KMR.CDD.LyQ.1934.03

Case No. P/110/34

With reference to your application dated.....
with a plan for the proposed building/additions and alterations on plot
No. 8, Survey Sheet No. K-18, Lyari Quarter
I have to request you to comply with the following requirements:—

PLAN OF PROPOSED BUILDING ON PLOT NO (ON LAND GRANTED TO) IN EXCHANGE TO PLOT NO 8. N. 18

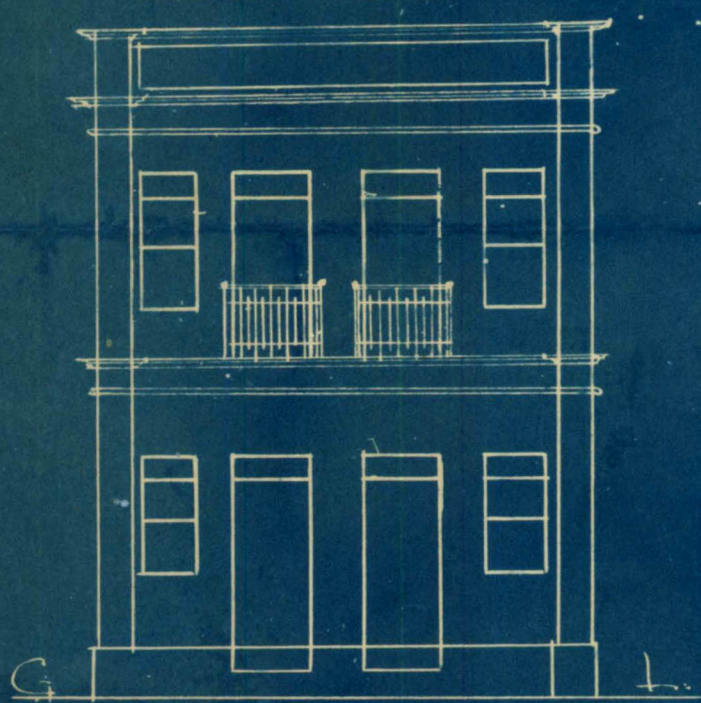
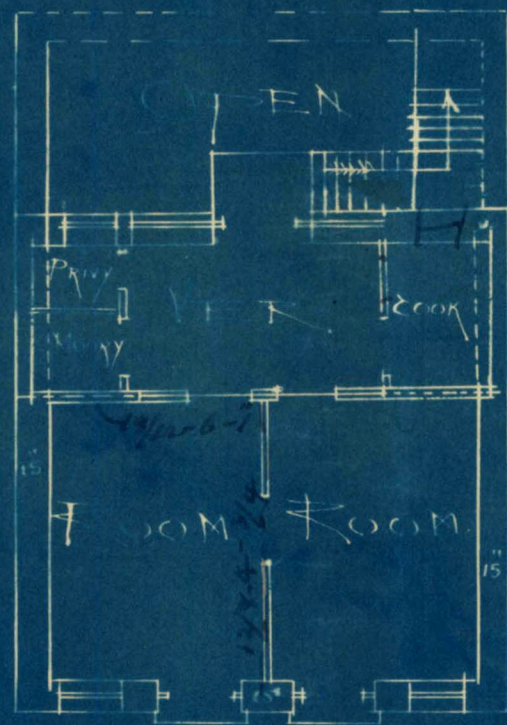
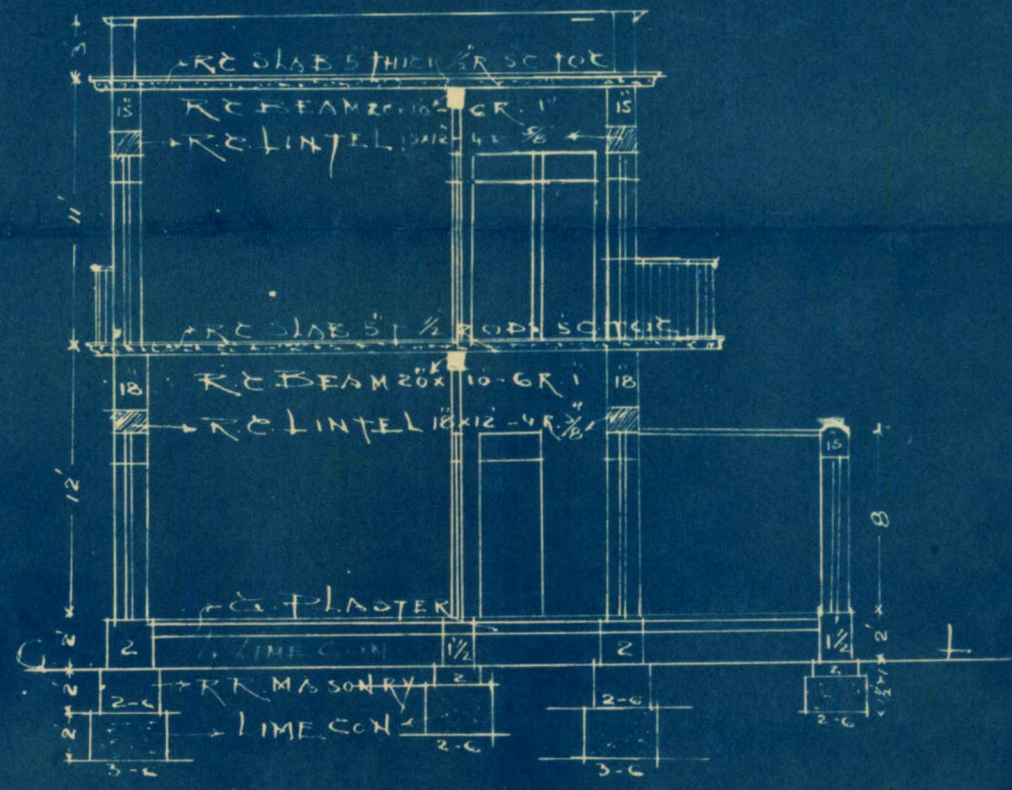
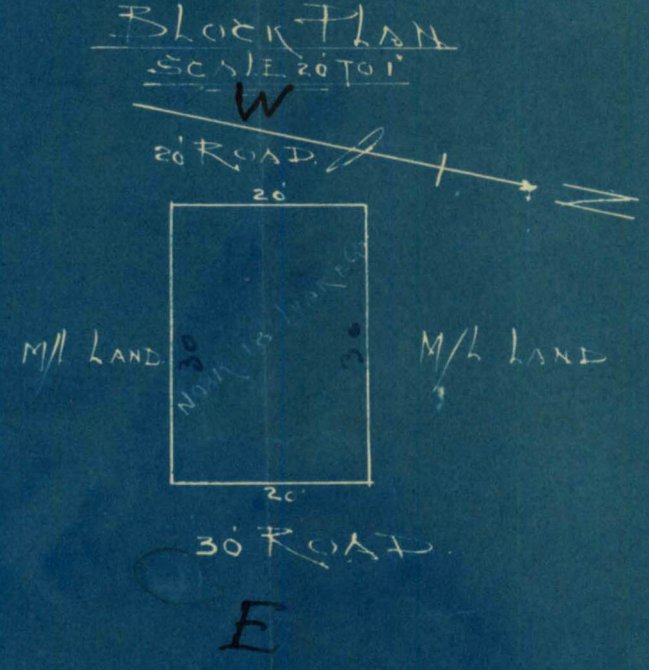
Side measurements are not completely shown *KMR. 15/3/34*

*In the layout - the plot is 10' x 30' = 60 sq. ft.
& 20 ft road west side 30 ft in east. Position
of the plot as Architect shown is alright - it should
be 10 instead of 20 ft plot wide. area of the plot
400 sq ft should be not shown. *19/3/34**

*The side measurements need be
corrected or altered or same.
produced.*

*What about S.E's of section
which should be connected.*

Separate cess pits should be built
for Privy & Bath. M. 10/3

1. Separate cesspits should be built for privy and bath.

With reference to your letter No. B.P. 116/34....
Dtd. 3.10.1934. Regarding Building construction on Plot
granted in exchange to Plot No. 8. K. 18 Layaree qrt.
I beg to inform that one Cesspul has already been pro-
vided in the open compound about 6' away from the Bath,
Prevey with a open channel to cesspul which is more than
sufficient for one tenement. and the same will meet with
your requirements and pass the plans at your earliest
convenience and oblige. Thanking you in advance.

Separate cesspit shown in
provided for Private Bath

Passed on with comp. to E.R. One extra cess port

PLAN OF PROPOSED BUILDING ON PLOT NO. (ON LAND GRANTED TO) IN EXCHANGE TO PLOT NO. 8, K. 18

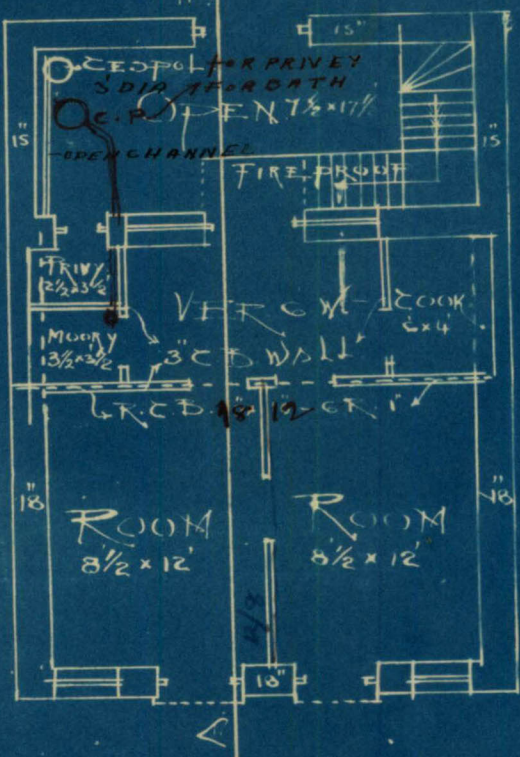
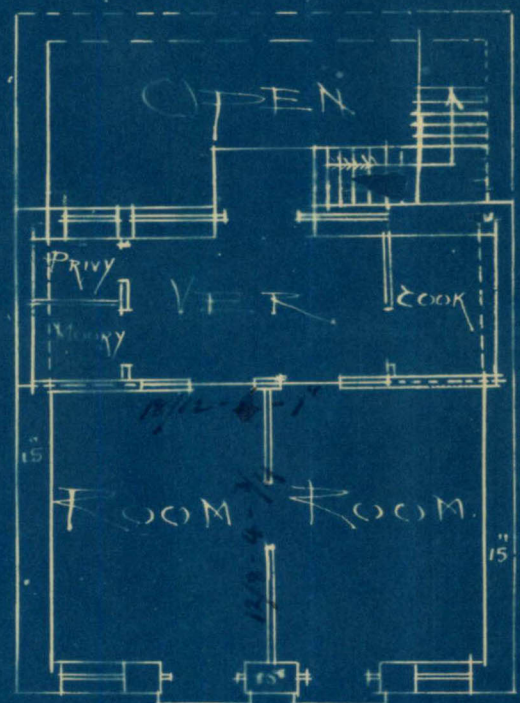
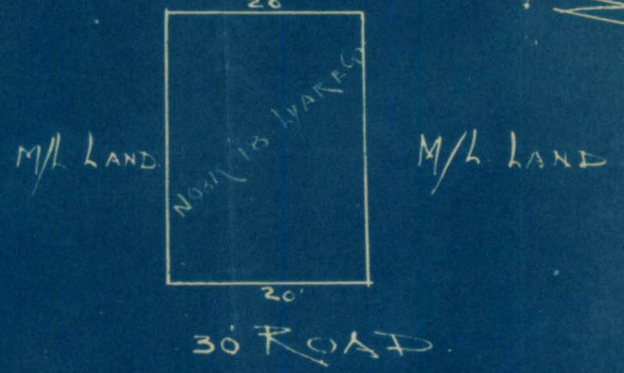
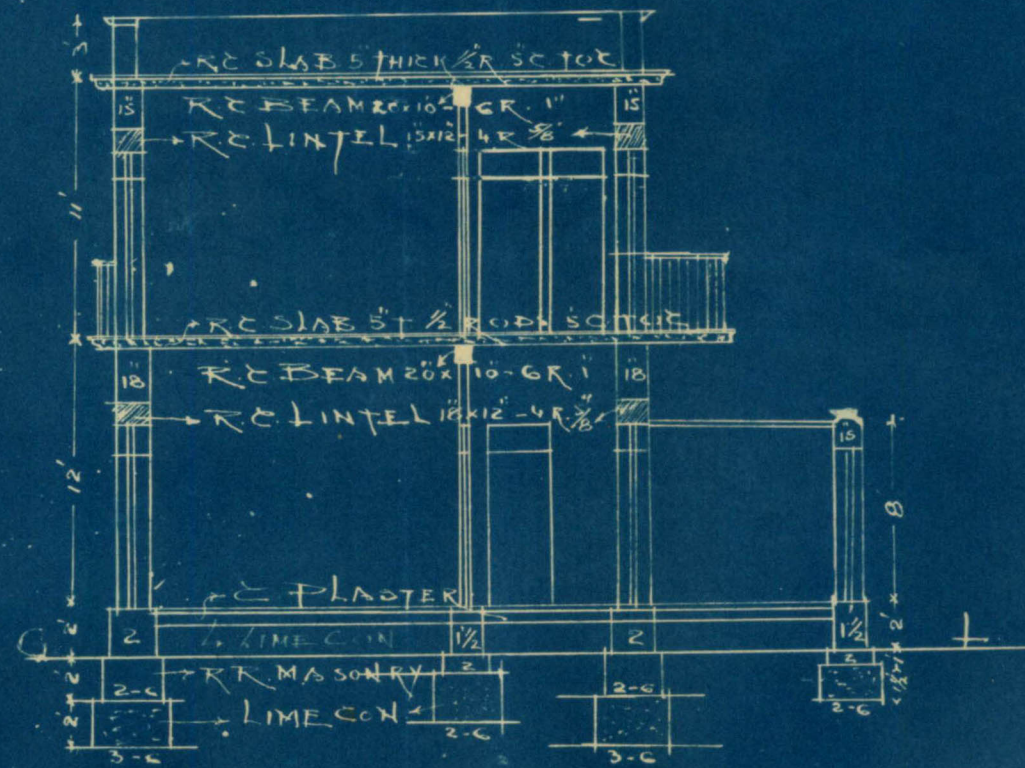
P. tell him that plans are neither
corrected nor signed by the land lord.

1. The plans are ~~neither~~ correct nor signed by the owner. Until this is done the plans could not be approved.

With reference to your letter No. 110/34 of 1.3.34 I beg to submit herewith two copies of plans (one on cloth) of proposed building on plot No. 8. K. 18 Layari quarter duly corrected. and request the same be approved at your earliest convenience of which
